URGENT: MEDICAL DEVICE CORRECTIVE ACTION-UPDATE
SINGLE USE LIGATING DEVICE

Product Name	Model/Catalog Number	Lot Number	UDI
SINGLE USE LIGATING DEVICE POLYLOOP	HX-400U-30	See attachment	04953170368615

Date: September 30, 2026

Operation Pipe breaking

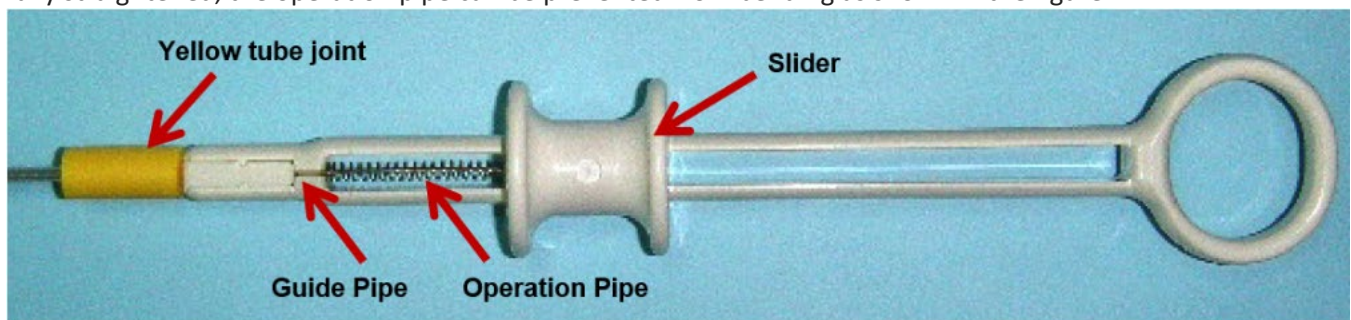
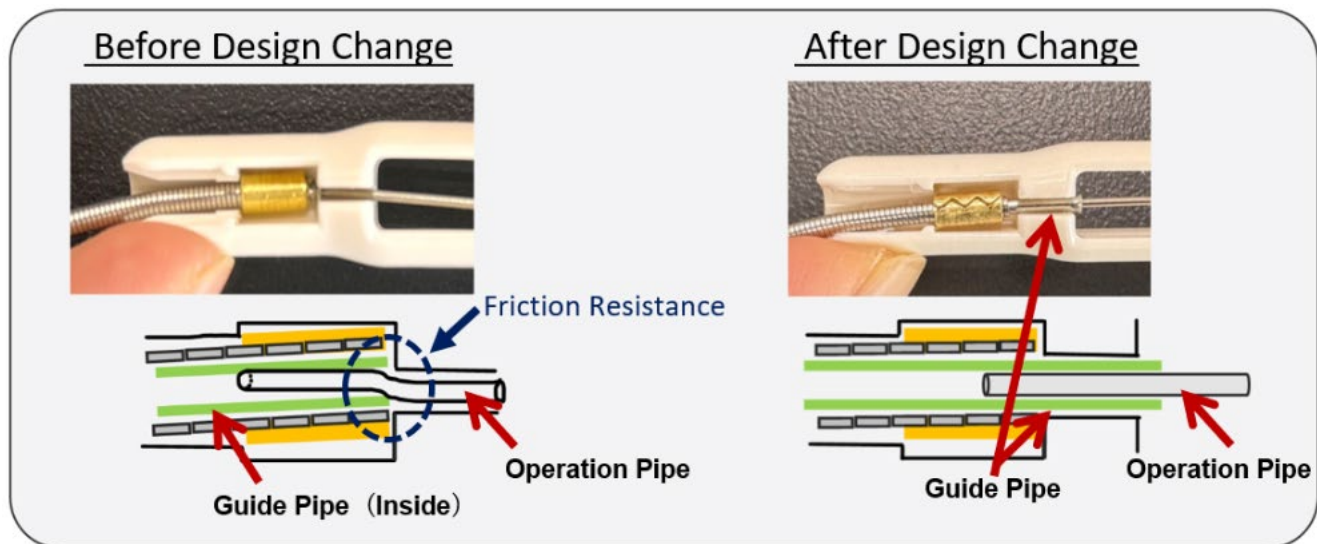
Olympus is introducing a design change to address complaints that the ligation loop was unable to release or detach as expected during use, with operation pipe breakage being one of the contributing factors to these complaints. (see image below).

Olympus revised the method used to secure the guide pipe. As a result, even if the sheath near the handle is not fully straightened, the operation pipe can be prevented from bending as shown in the figure.

■ **Do not hold the loop with the distal end of the tube sheath while the loop is surrounding the tissue. (refer to page 5 in the manual)**

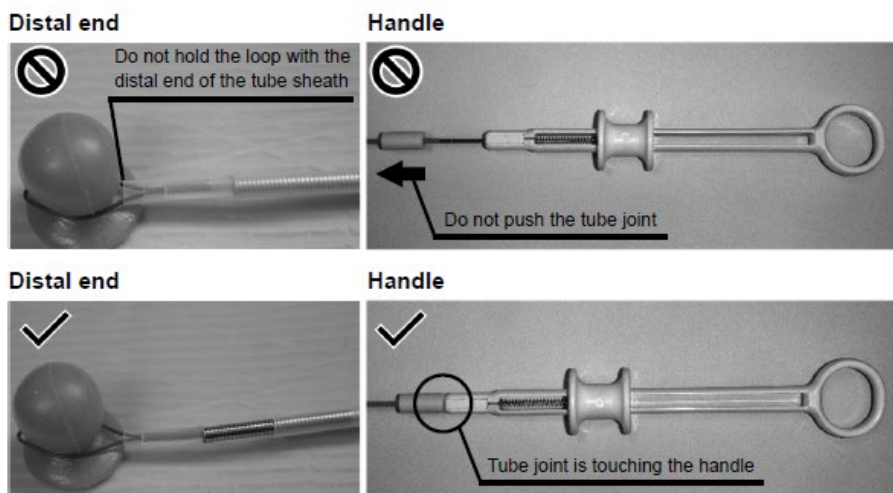
Otherwise, when the tissue is ligated, the loop may be detached from the hook in the tube sheath and tangled with the hook.

- ***Do not remove the loop from the hook while the coil sheath is not extended from the tube sheath. (refer to page 6 in the manual)***

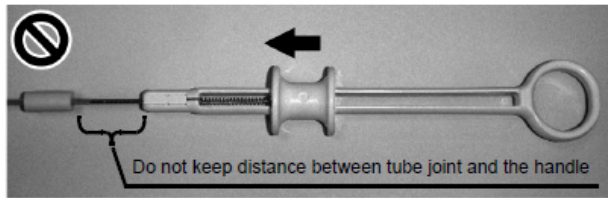
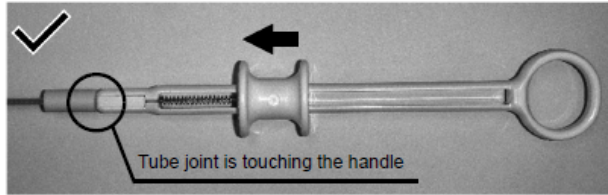
Otherwise, the loop may be tangled with the hook and become impossible to be removed.

- ***With the proximal end of the tube sheath and handle kept straight against the biopsy valve of the endoscope, push the slider when detaching the loop. (refer to page 6 in the manual)***

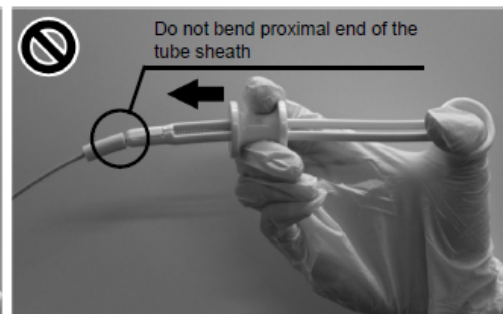
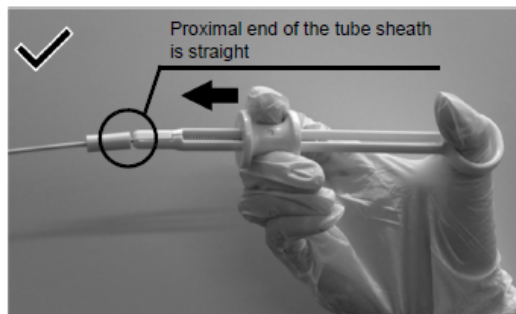
Bending the proximal end of the tube sheath will increase frictional resistance, which may damage the handle when pushing the slider.
